R90 – 2023

Certificate of Appropriateness for work in the Historic Districts:

**Historical Architectural Review Board
COA Final Review Sheet**

HDC-2022-00071; Amendment
Address: 346 N. 8th Street
District: Old Allentown Historic District
Applicant: Andrew Ardizzoia, owner; Tom Weidner, contractor
Proposal: Reconfigure and replace front steps; install railing

**Existing steps at 346 N. 8th Street.
(Applicant)**

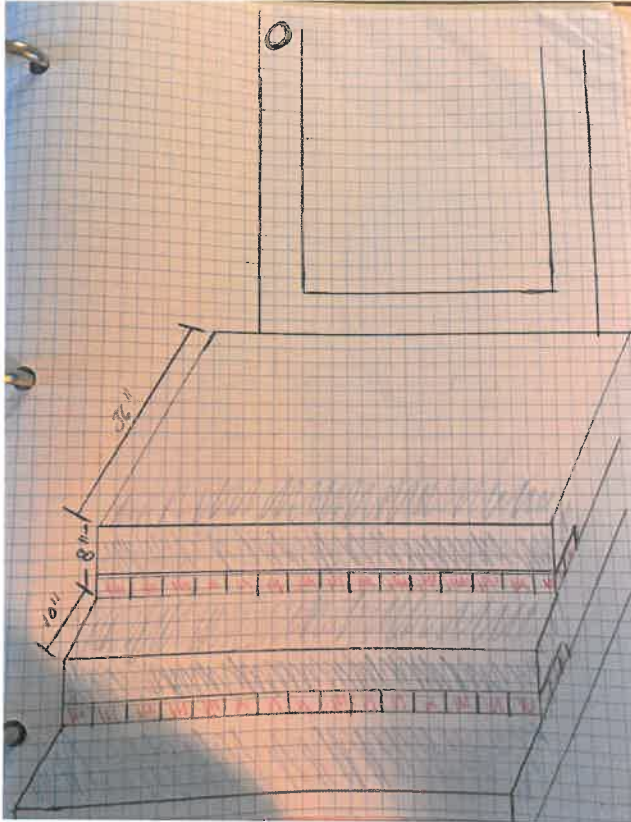
From 8th Street, the building appears as a two-story detached or semi-detached frame structure with a parapet and former commercial storefront and differs from the block's two- and three-story brick rowhouses. Sanborn maps show that the rear portion of the building is brick. According to a 1982 clipping in the Planning & Zoning property files, the brick portion of the building was constructed in the 1860s, and the wood structure was moved to the site from elsewhere in the city and placed in front of the brick building to function as a bakery. The 1891 and 1897 Sanborn maps show that the building was originally set back from 8th Street, and by 1911 it had been expanded to align with the fronts of the adjacent buildings. Because of the building's move and expansion, it is likely that the steps were rebuilt several times. The difference in the brick of the building's foundation and the circular steps suggests that the brick steps are a later addition, constructed after the c. 1911 expansion. Staff finds that the circular brick steps are not in character with the wood structure and have not acquired significance in their own right.

**Revised proposal for front steps.
(Applicant)**

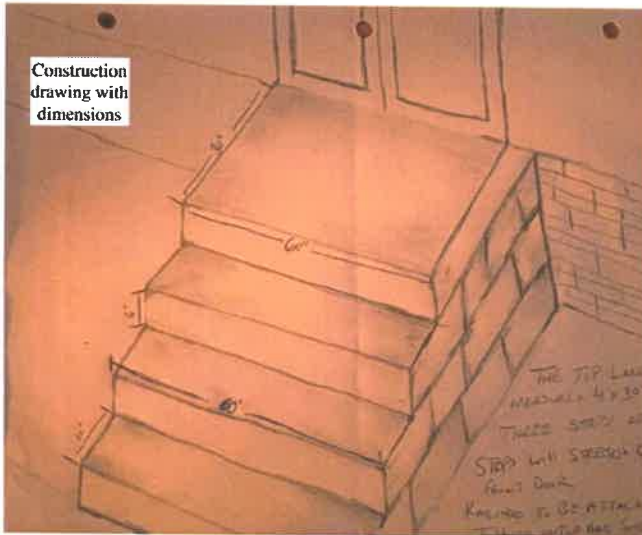
The application has been revised to comply with building code and avoid impeding in the right-of-way. According to the applicant, using standard stone slabs would require an additional step and would increase the projection into the right-of-way. The applicant further noted that custom stone slabs would be prohibitively expensive. The solution the applicant devised to meet building code is to include one course of bricks below each slab to raise the height of the step and eliminate the need for the additional step in the right-of-way. Staff finds the proposal acceptable since the steps are not intended to replicate an original condition. Steps at neighboring properties include a combination of slate treads and brick risers. Staff questions whether the combination of slate treads and brick risers would be more appropriate.

The proposed railings would consist of wood top and bottom rails with metal spindles and a wood newel post. Because the building is frame construction, staff finds the combination of wood and metal acceptable. Staff recommends anchoring the railing to the ground rather than the stone slab steps, since anchoring directly into the steps can accelerate deterioration.

The contractor and owner are agreeable to following the building code and HARB recommendations. Building Standards and Safety recommends a riser height of 8 ¼ inches for the steps.

Mr. Huber moved to approve the application presented on 5/1/2023 for the reconfiguration and replacement of front steps and installation of railings at 346 N. 8th Street, with the staff to review details, pursuant to Chapter 3, Section 3.7 Porches & Steps, with the comment that the applicant may also consider a railing design consisting of all metal or all wood. Mr. Hart seconded the motion, which carried with unanimous support.
